Access Compliance Report

Public Rights-of-Way

(Curb Ramps)

Intersection ID: 13679	Main Street: EUCLID_AV	Cross Street: LEXINGTON_AV	Location: N
ADA ID: F833104E9BD9	Ramp Type: PerpDiag	Initial Pass/Fail: Fail	Overall Compliance: No
Severity Score: 26.25

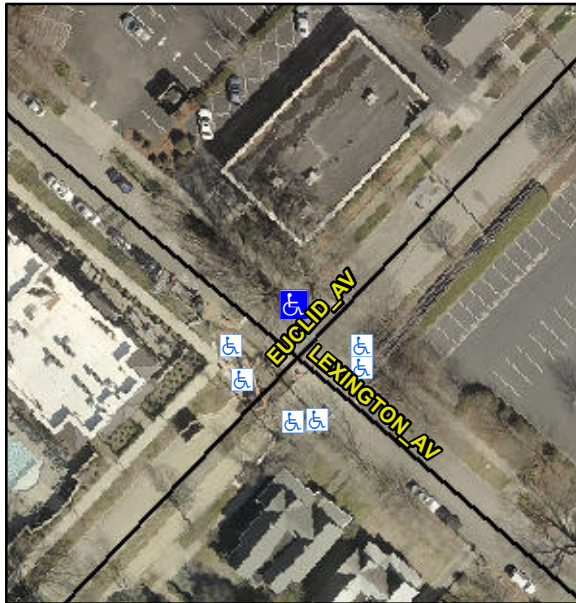
Not Found, R304.2.2, R304.5.3

Compliance	Description	Data	Compliance	Description	Data
N/A	Ramp Length (in)	101.0	No	Ramp Slope (%)	16.2
Yes	Ramp Width (in)	72.0	No	Ramp XSlope (%)	2.9
N/A	Flare Type LT	N/A	N/A	Flare Type RT	N/A
N/A	Flare Slope LT (%)	N/A	N/A	Flare Slope RT (%)	N/A
N/A	Flare Traversable LT?	N/A	N/A	Flare Traversable RT?	N/A
N/A	Landing Length (in)	N/A	N/A	DWS Provided?	N/A
N/A	Landing Width (in)	N/A	N/A	DWS Contrast?	N/A
N/A	Landing Slope (%)	N/A	N/A	DWS Length (in)	N/A
N/A	Landing X Slope (%)	N/A	N/A	DWS Full Width?	N/A
N/A	Landing Curb? (Y/N)	N/A	N/A	DWS Offset (in)	N/A
N/A	Shared Landing?	N/A			
N/A	Gutter Ponding?	Yes	N/A	Gutter Slope (%)	N/A
N/A	Gutter Lip Ht (in)	N/A	N/A	Gutter X Slope (%)	N/A
N/A	Painted X Walk1?	No	N/A	Painted X Walk2?	No
	X Walk 1 Direction	To SW		X Walk 2 Direction	To SE
N/A	X Walk 1 Width (in)	N/A	N/A	X Walk 2 Width (in)	N/A
	X Walk 1 Slope (%)	1.2		X Walk 2 Slope (%)	1.6
	X Walk 1 X Slope (%)	0.9		X Walk 2 X Slope (%)	0.3

Remove & Replace Curb Ramp With Two New Directional Ramps or Equivalent.
